HISTORIC AND DESIGN REVIEW COMMISSION

HDRC CASE NO: 2021-065
ADDRESS: 1024 DAWSON ST
LEGAL DESCRIPTION: NCB 1371 BLK 3 LOT E 38 FT OF 14
ZONING: RM-4, H
CITY COUNCIL DIST.: 2
DISTRICT: Dignowity Hill Historic District
APPLICANT: Mark Flinn/FLINN MARK
OWNER: Mark Flinn/FLINN MARK
TYPE OF WORK: New construction of a 2-story rear accessory structure
APPLICATION RECEIVED: January 21, 2021
60-DAY REVIEW: Not applicable due to City Council Emergency Orders
CASE MANAGER: Edward Hall

The applicant is requesting conceptual approval to construct a 2-story, rear accessory structure on the lot at 1024 Dawson, located within the Dignowity Hill Historic District.

ELEVATIONS

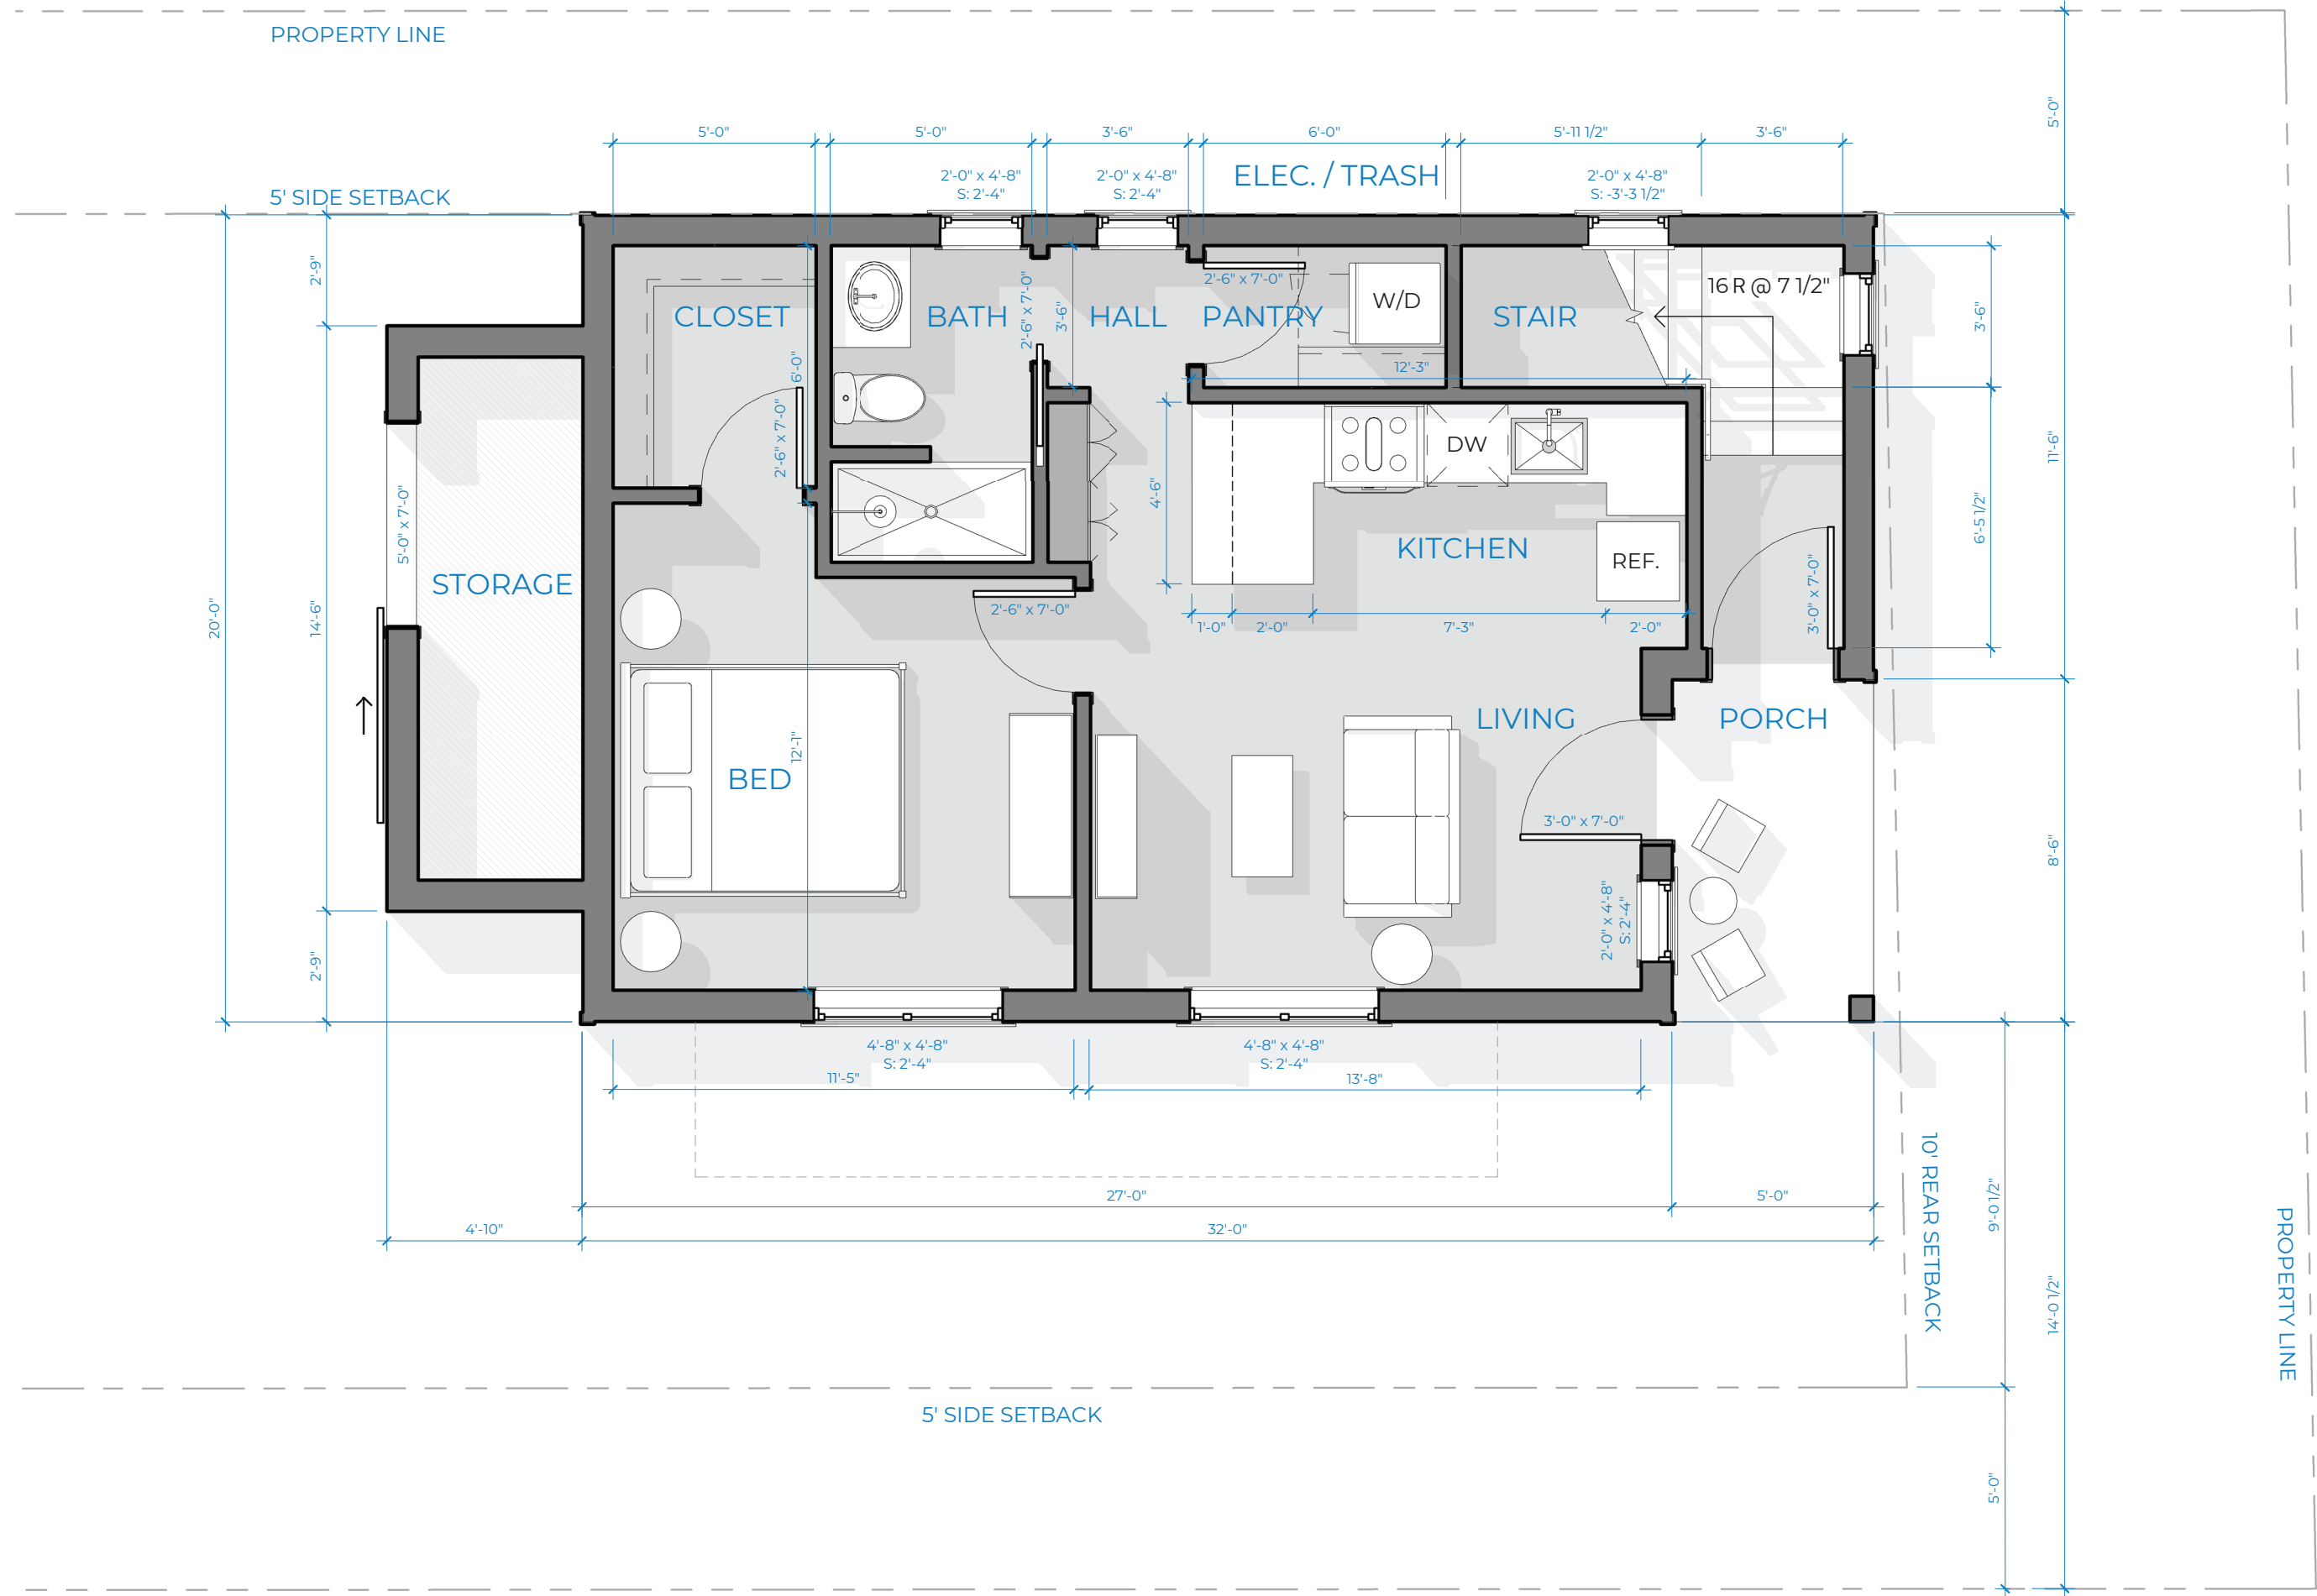
- d. **MASSING & FORM** – Regarding overall height, the applicant has proposed for the structure to feature an approximate height of thirty (30) feet. The applicant has submitted a line of sight study that notes that the proposed two story structure would not be visible from the right of way due to its distance from the right of way at Dawson. Staff finds that the applicant should perform studies to determine whether or not the structure's height can be further reduced, potentially through a reduction in roof form and roof height.

- g. **CHARACTER (Fenestration)** – The Guidelines for New Construction 5.A. notes that new accessory structures should relate to the primary historic structure in regards to their materials and window and door openings. The applicant has noted that the north and south elevations have been mislabeled, and that the proposed blank elevation will face the interior of the lot, and not the alley. Staff finds that the proposed accessory structure currently features window openings and fenestration patterns that are atypical of those found on the primary

historic structure, and are inconsistent with the Guidelines. Staff finds that all windows should feature sash profiles, and that fenestration should be added to the elevations labeled south and east, which are currently either void of fenestration, or feature large, unseparated wall planes. Additionally, staff finds that windows on the proposed accessory structure should feature profiles and sill details that are consistent with those of the primary historic structure on the lot.

- i. That the applicant perform studies to determine whether or not the structure's height can be further reduced, potentially through a reduction in roof form and roof height.
- ii. That all windows feature sash profiles, and that fenestration should be added to both the south and east elevations, which are currently either void of fenestration, or feature large, unseparated wall planes. Additionally, staff recommends that windows on the proposed accessory structure should feature profiles and sill details that are consistent with those of the primary historic structure on the lot.
- iii. That in developing construction documents for final approval, the applicant match the materials of the primary historic structure.
